**ADDENDUM  
NO. 3**

**September 30, 2025**

**VALE FACILITY ADDITION/RENOVATIONS AND  
MAINTENANCE/IT FACILITY PROJECTS**

**Addendum Three (AD.03)** to the drawings and specifications prepared by Gibraltar Design for **Valparaiso Vale Facility Addition/Renovations and Maintenance/It Facility and Related Work** for Valparaiso Community Schools, Valparaiso, Indiana.

**10 Door A113**  
A-411 3/4" = 1'-0"

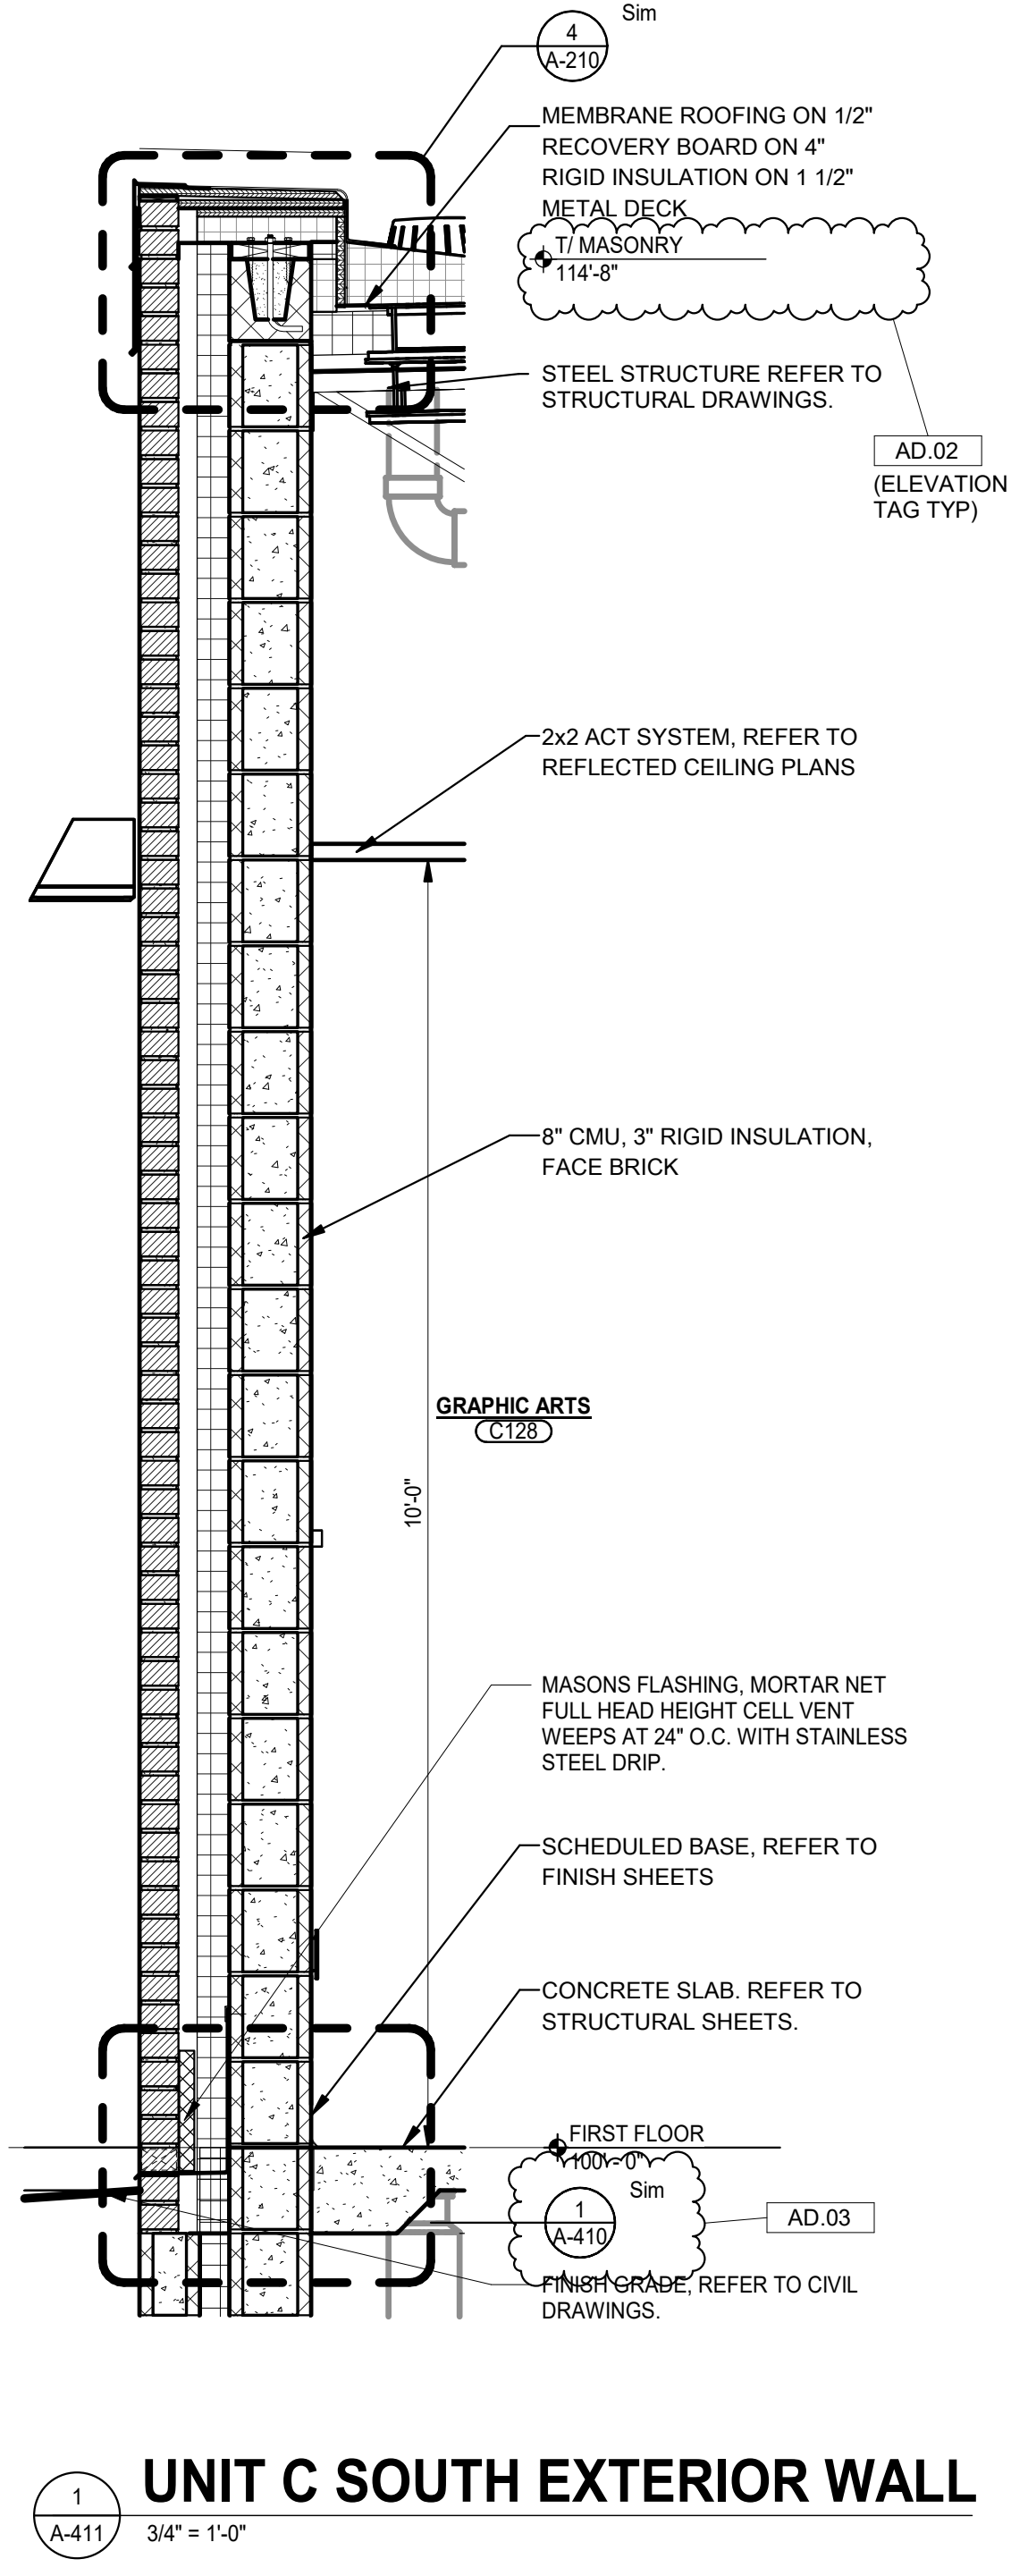
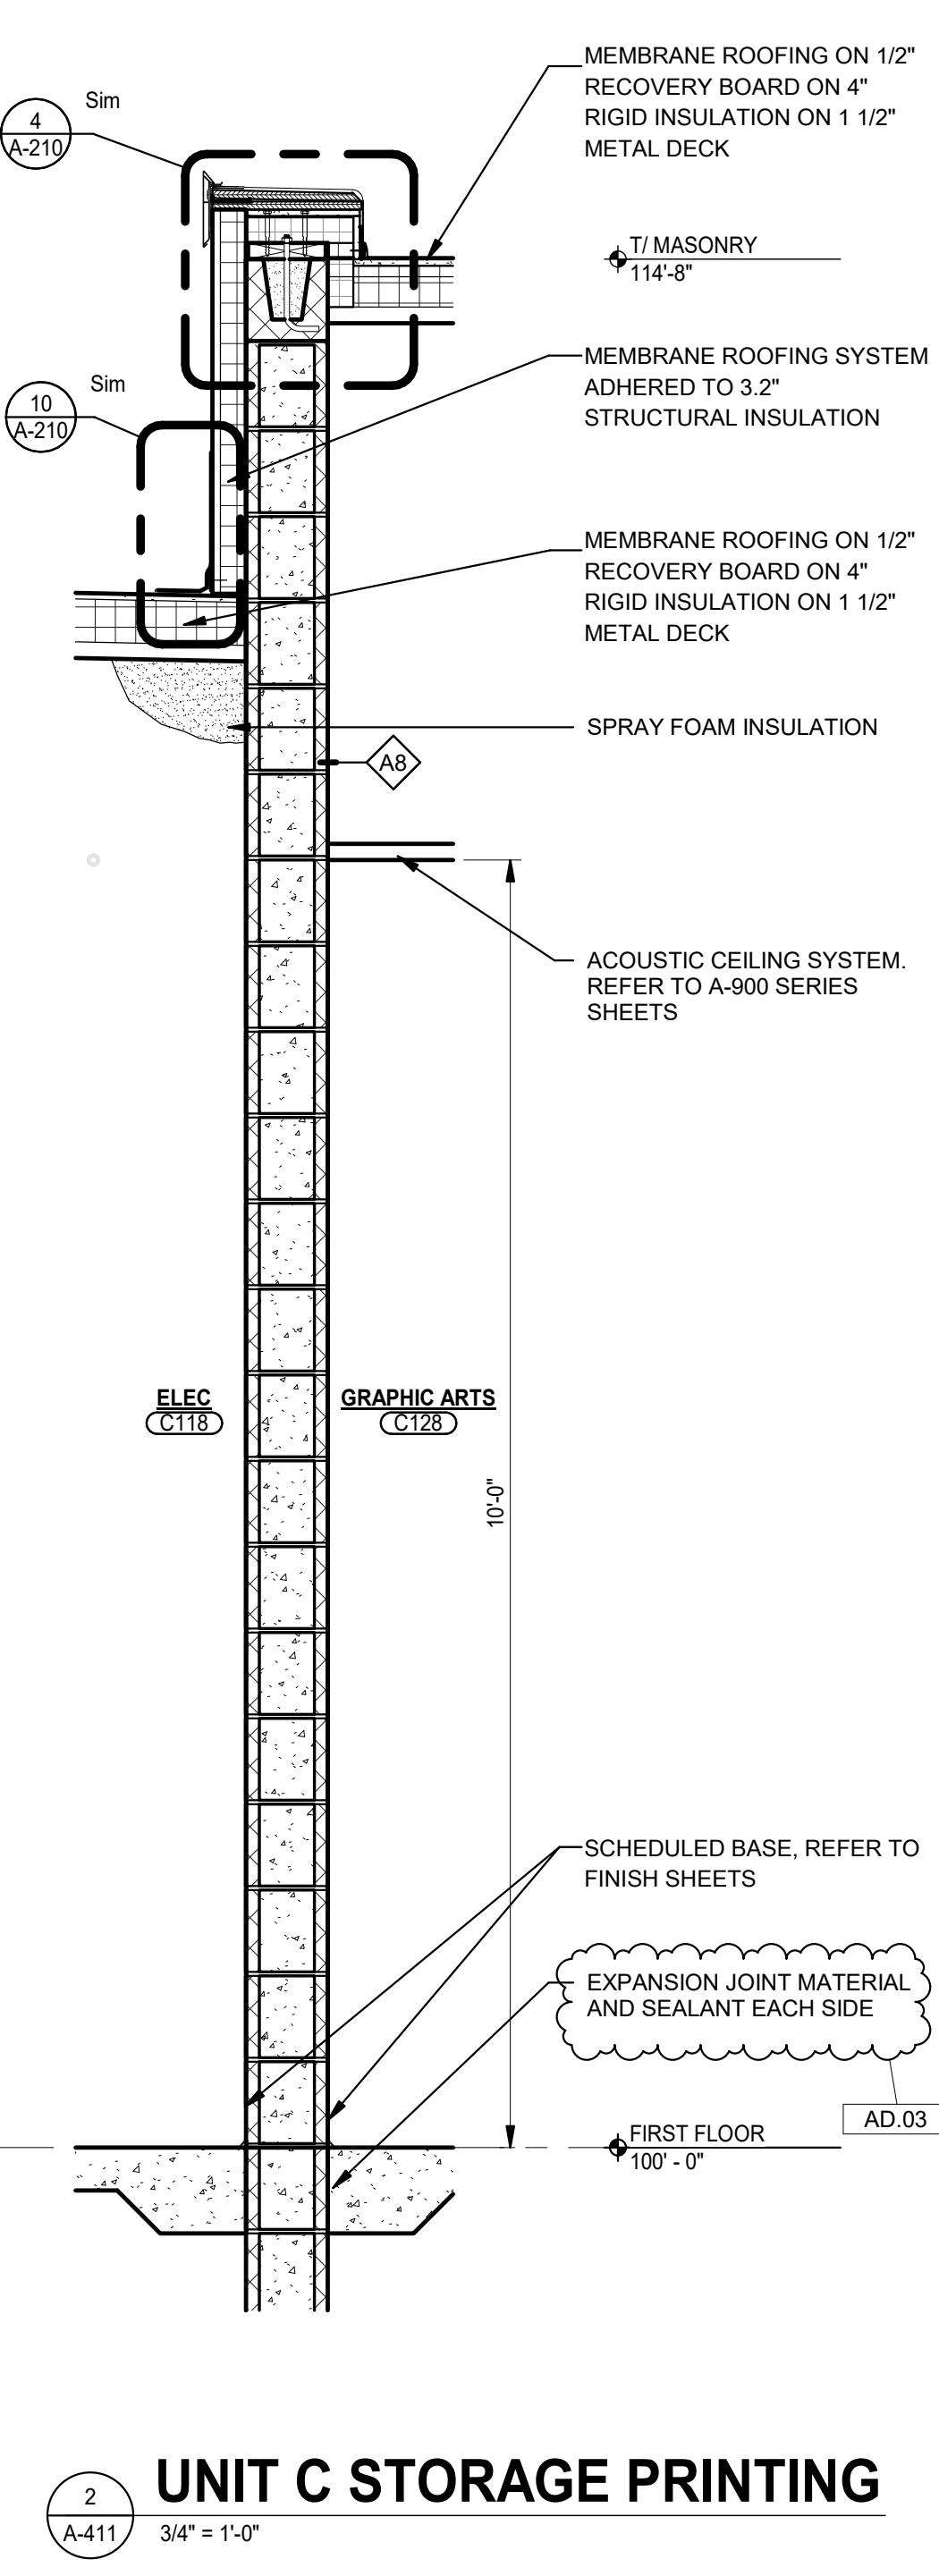
- A. Refer to revised, full-size drawing, included in this Addendum, for revisions.
  - 1. Added / Clarified expansion joints at slab to wall conditions.
  - 2. Clouded bottom of new exterior walls to refer to detail 1/A-410.

1 FOODSERVICE LAYOUT  
 1/4" = 1'-0"

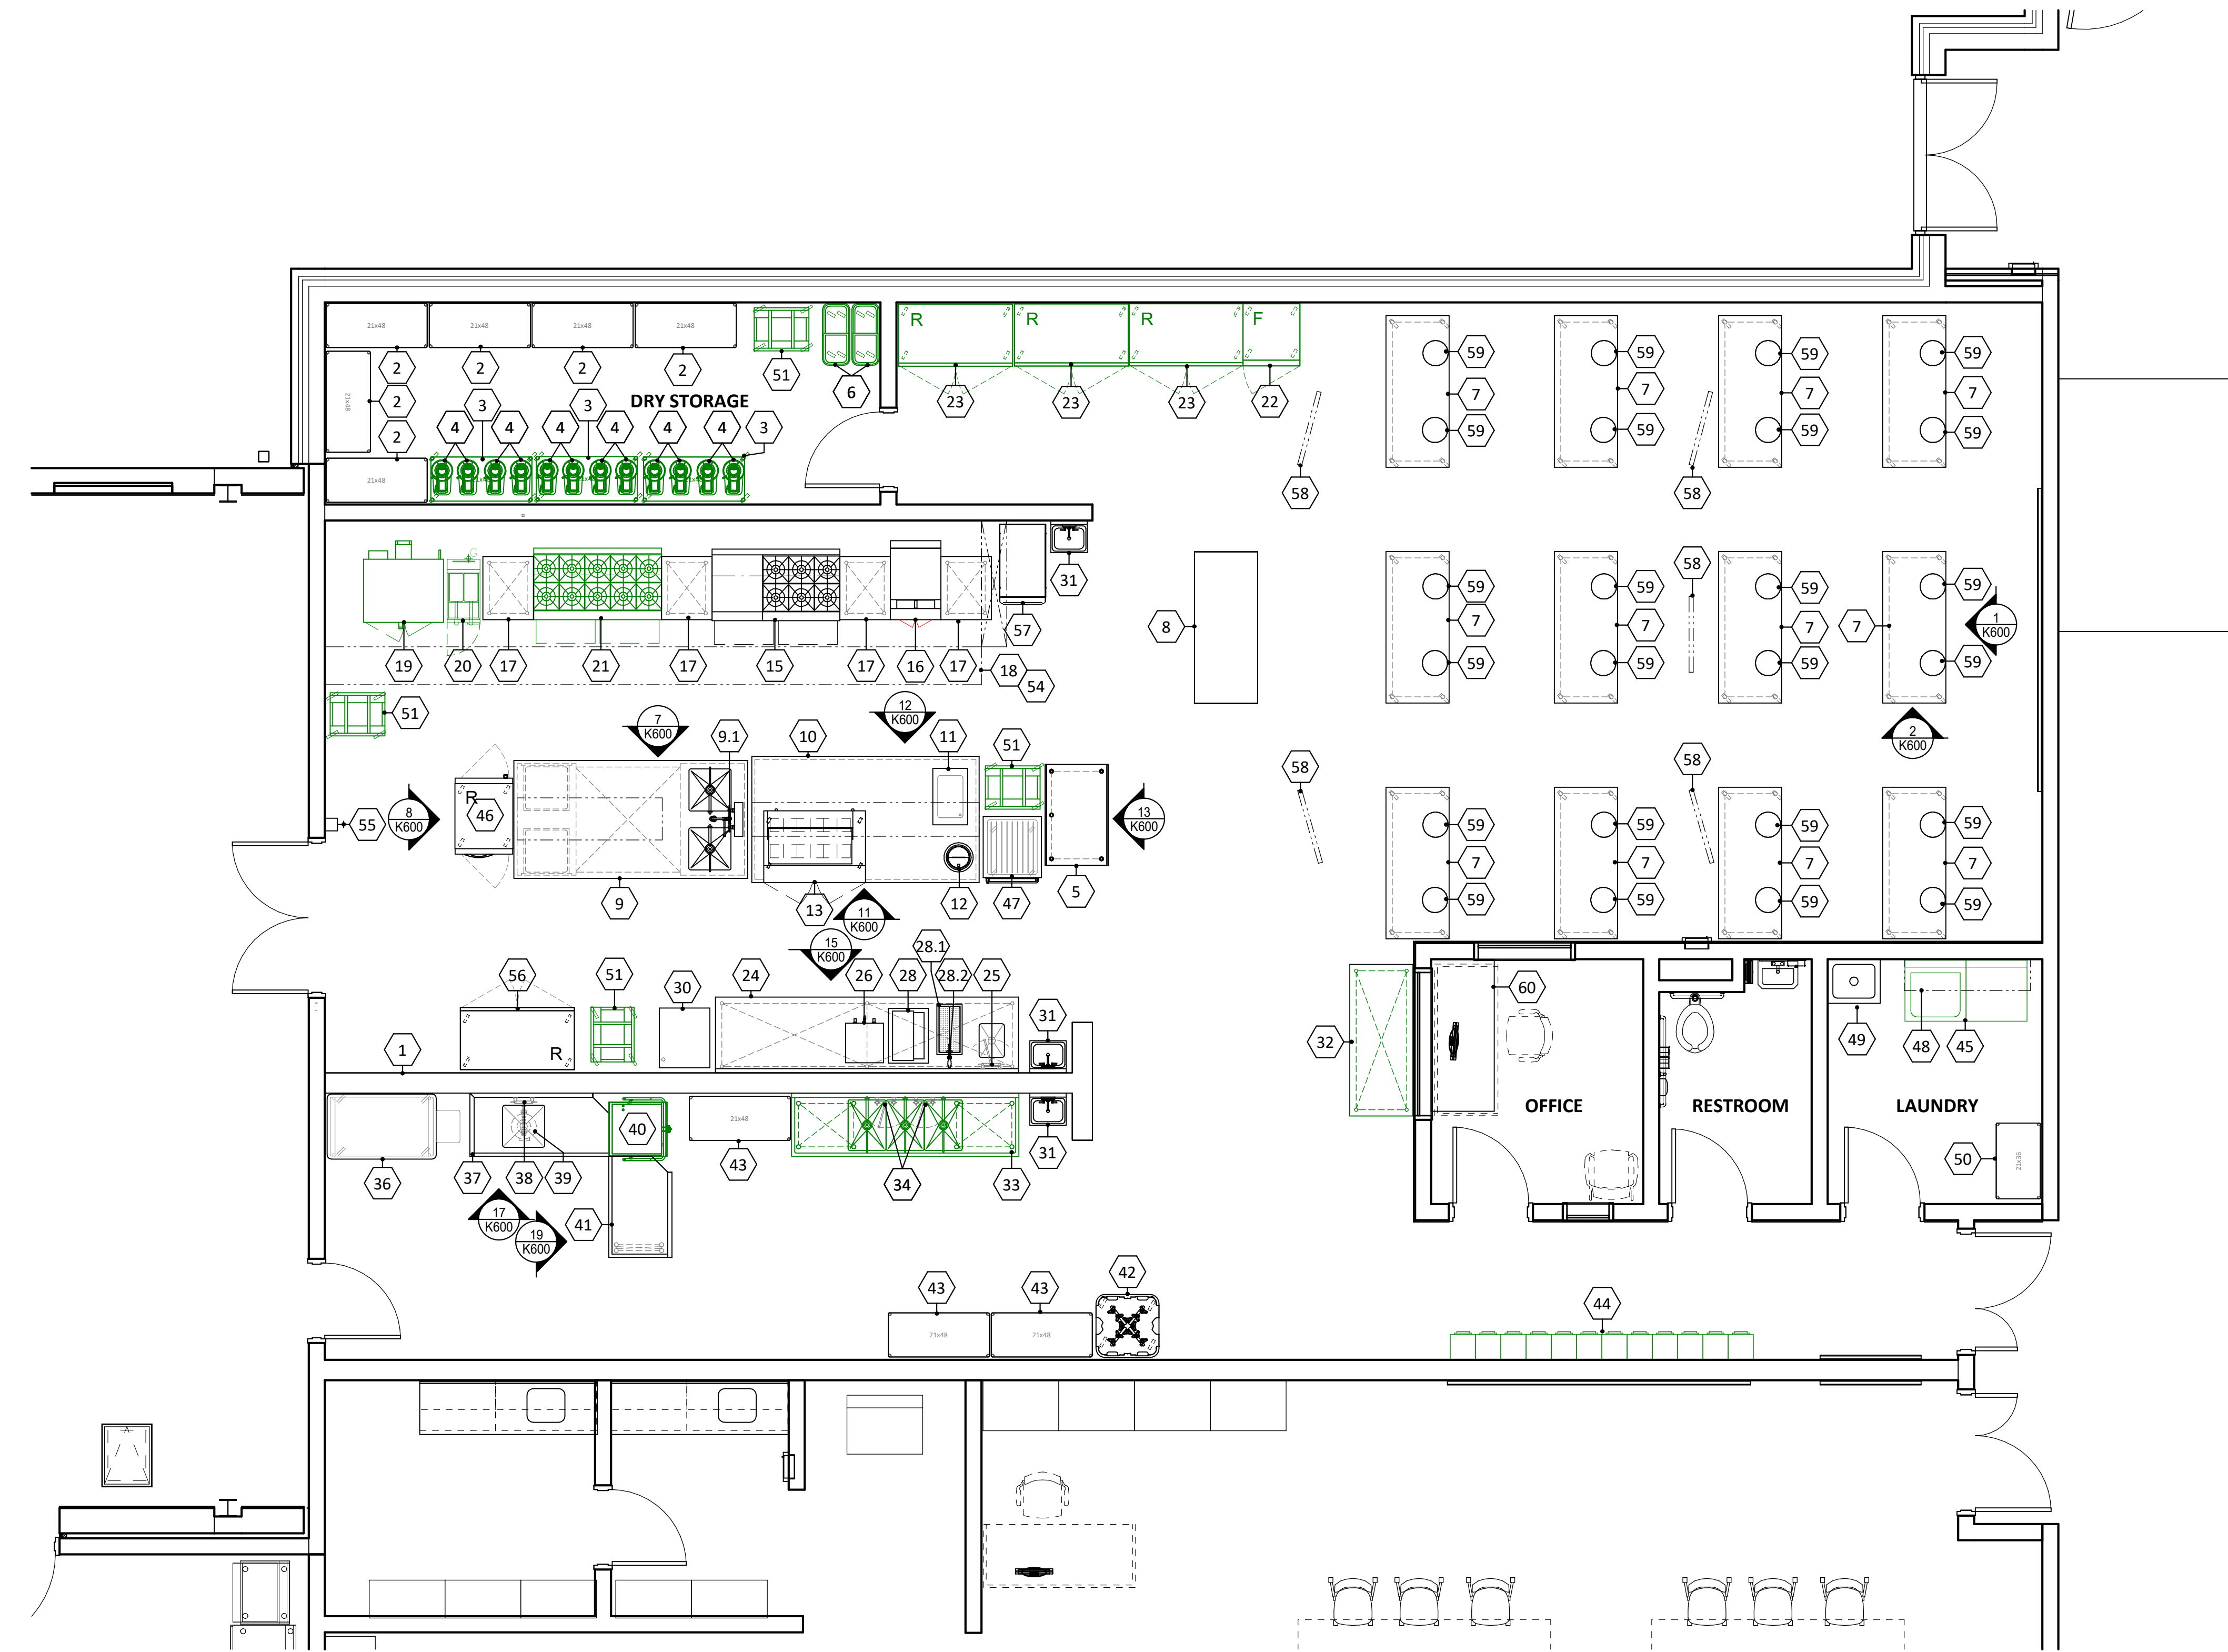
- A. Refer to revised, full-size drawing, included in this Addendum, for revisions below.
  - 1. Revise schedule for Item #11: Manufacturer/Model Number changed to By Owner/Not in KEC Contract.

- A. Refer to revised, full-size drawing, included in this Addendum, for revisions below.
  - 1. Revise schedule for Item #11: Manufacturer/Model Number changed to By Owner/Not in KEC Contract.
